## **PLANNING COMMISSION MEETING**

Farmington Planning Commission Staff Report	Planning Commission Date: January 12, 2026	Reference Number
<b>Submitted by:</b> Chris Weber, Assistant City Manager		
<b>Description</b> Proposed Building Façade Modification – Downtown Offices, 33211 Grand River		
<b>Motion:</b>		
Motion to approve the proposed façade modifications for Downtown Offices, 33211 Grand River because they meet the requirements of Section 35-104 of the Zoning Ordinance subject to the conditions described in the Façade Review Letter from OHM dated January 6, 2026.		
OR		
Move to approve the proposed façade modifications for Downtown Offices, 33211 Grand River because they meet the requirements of Section 35-104 of the Zoning Ordinance subject to the conditions described in the Façade Review Letter from OHM dated January 6, 2026 as well as the following modifications _____.		
OR		
Move to deny the proposed façade modifications for Downtown Offices, 33211 Grand River because they do not meet the requirements of Section 35-104 of the Zoning Ordinance

**To:** Chris Weber, Assistant City Manager  
**cc:** Jennifer Morris, Principal, OHM  
**From:** Kristen Hatfield, Senior Plann

SHEET# A-2  
 DATE:  
 JOB#

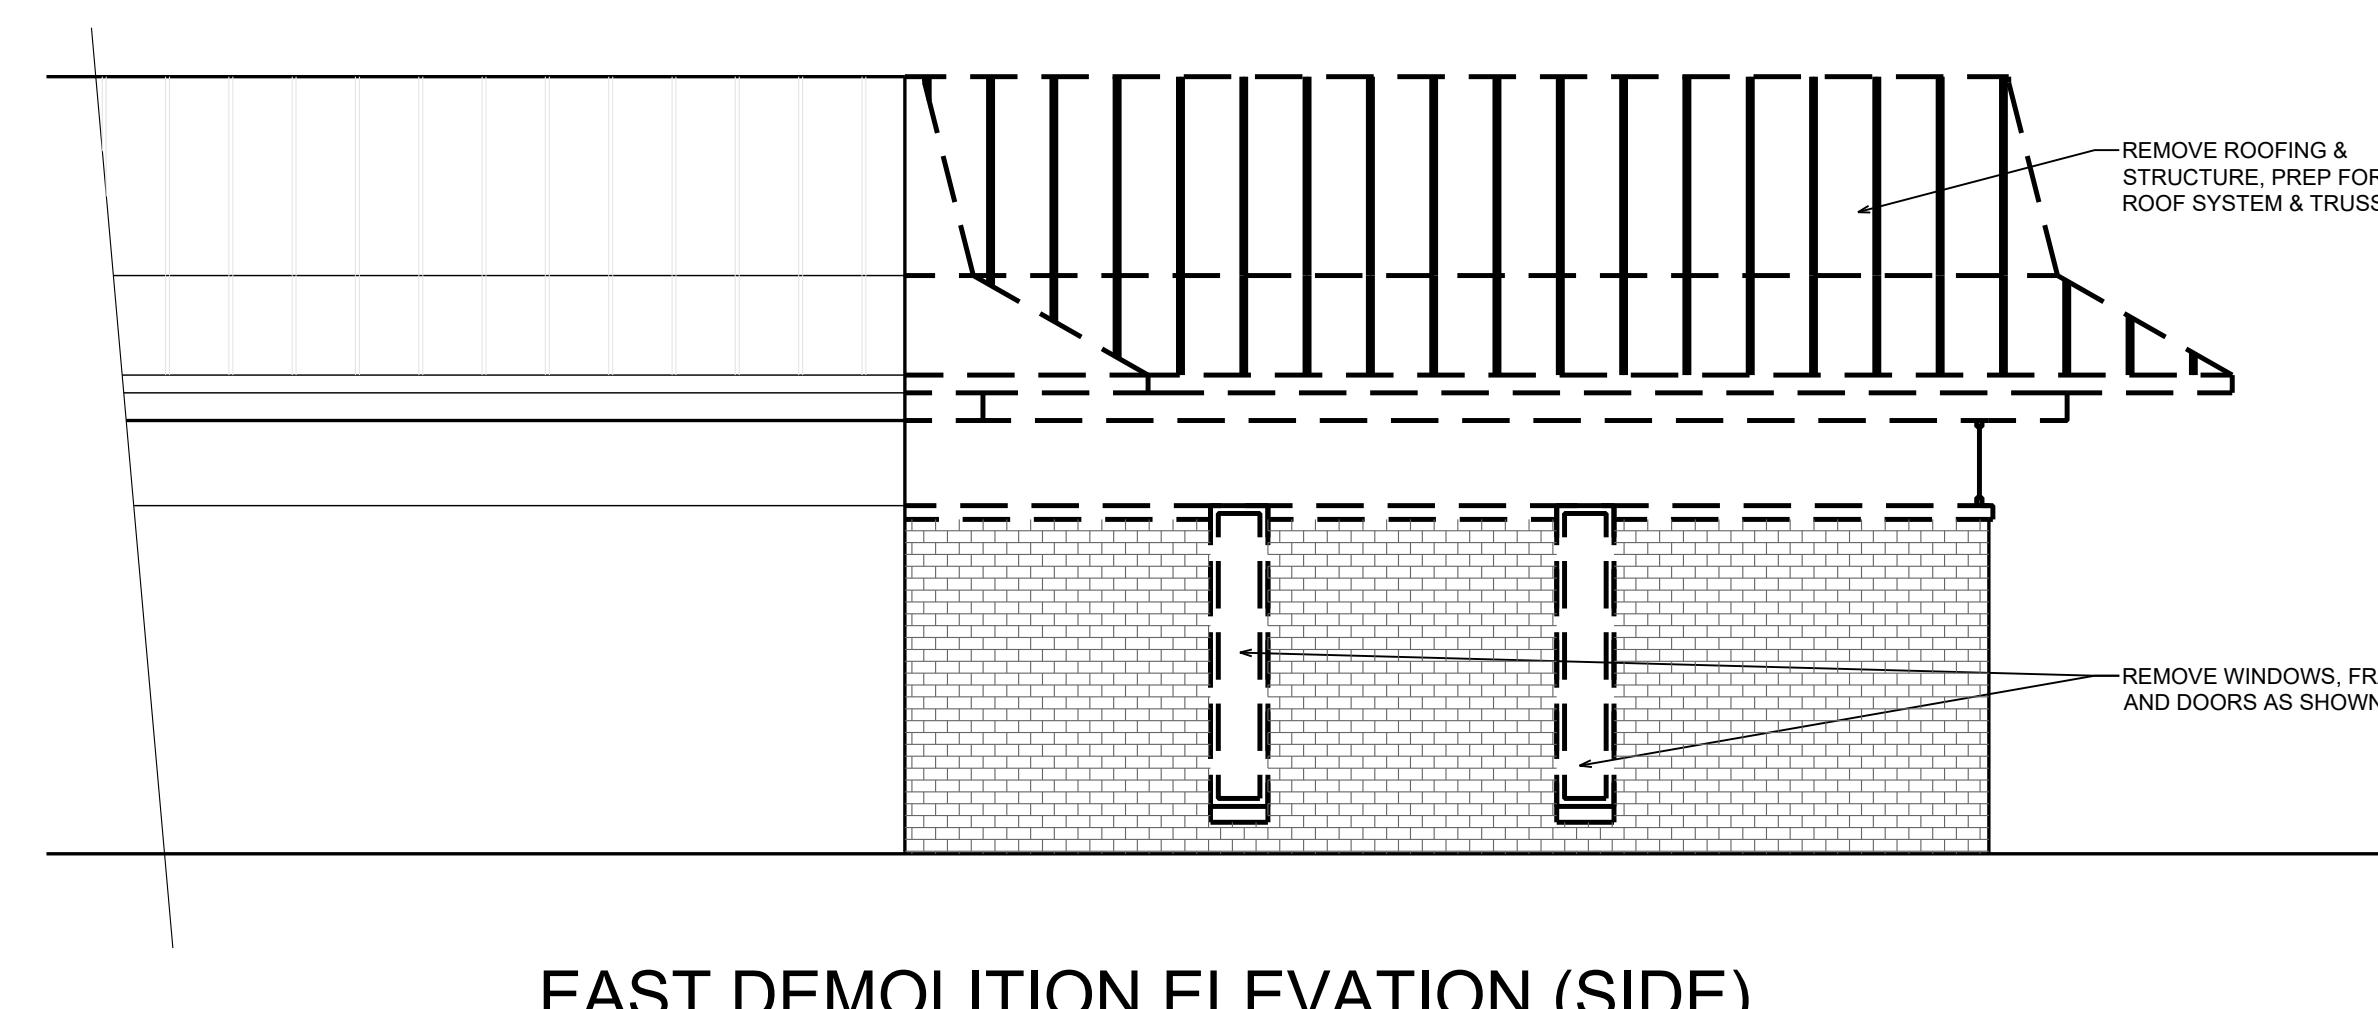
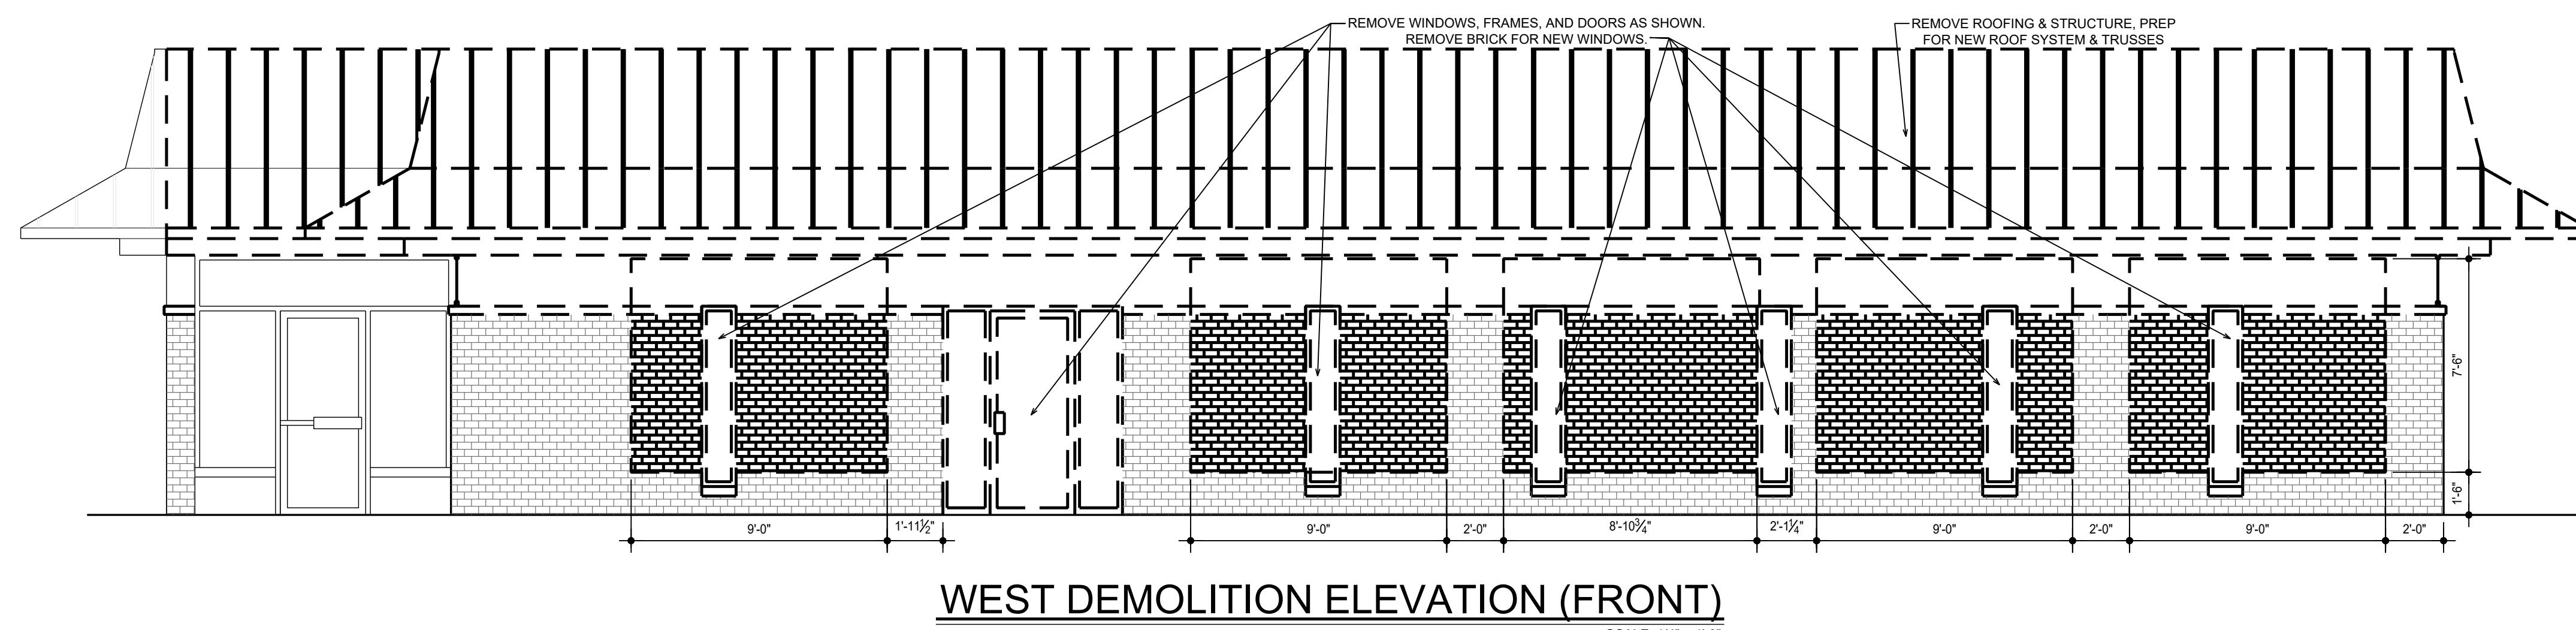
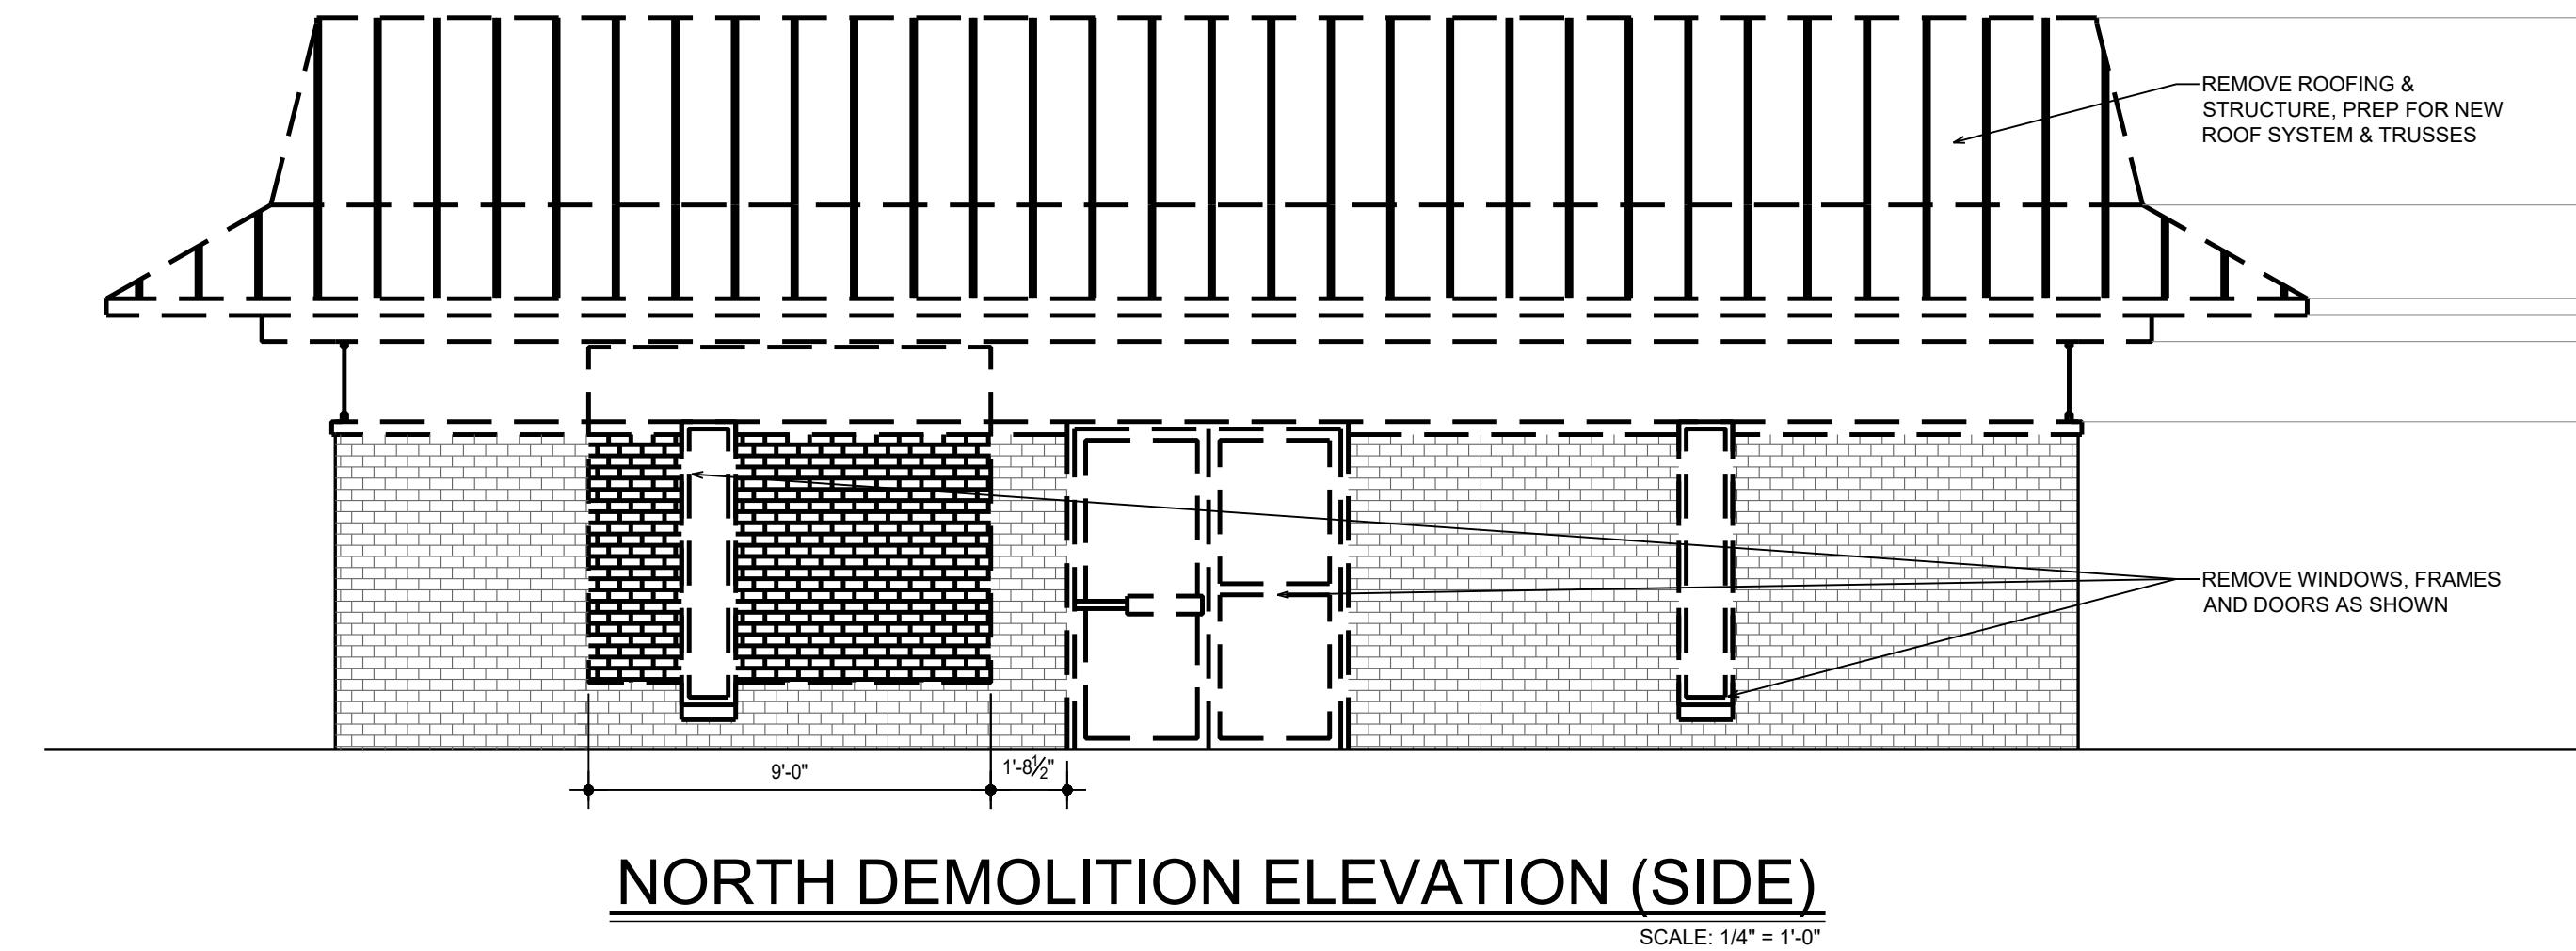
- c. **Building Design.**
  - i. **Purpose.** The façade improvements as presented appear to meet the purpose of the ordinance.
  - ii. **Main Entrance.** The elevations show entrance(s) that are located on the Grand River Avenue street front. Additionally, entrances have design details that enhance the appearance and prominence of the entrance so that it is recognizable from the street and parking areas. We note that while the ordinance requires a front entranceway that is inset a minimum of three (3) feet from the front building wall, this is an existing nonconforming structure.

- iii. **Roofs.** The applicant proposes to demolish portions of the existing roof and construct one that appears to be flat from the street with a small parapet, bringing it into conformance with the ordinance. We note that all rooftop-mounted equipment should be screened from view on all sides of the building; if any rooftop-mounted equipment is proposed it be shown on the site plan, along with method of screening.

Required	Proposed	Comment
Wall shall be constructed of at least seventy-five (75) percent modular brick or stone.	Eight-three (83) percent of the proposed façade is brick.	<b>Meets the intent of the ordinance.</b>
Up to twenty-five (25) percent of the remaining wall area may include other materials.	Seventeen (17) percent of the proposed façade is EFIS, an accent material permitted by the ordinance.	<b>Meets the intent of the ordinance.</b>

- 1. Nonresidential and Mixed-Use Development Requirements in the CBD District (§35-104).** If any rooftop-mounted equipment is proposed, it should be shown on the site plan along with method of screening.
- 2. Nonresidential and Mixed-Use Development Requirements in the CBD District (§35-104).** All required window areas shall consist of clear glass windows, clear glass doors and clear glass panels.
- 3. Site Plan Submittal Requirements (§35-165).** The applicant should provide material samples to the Planning Commission for their review and approval.
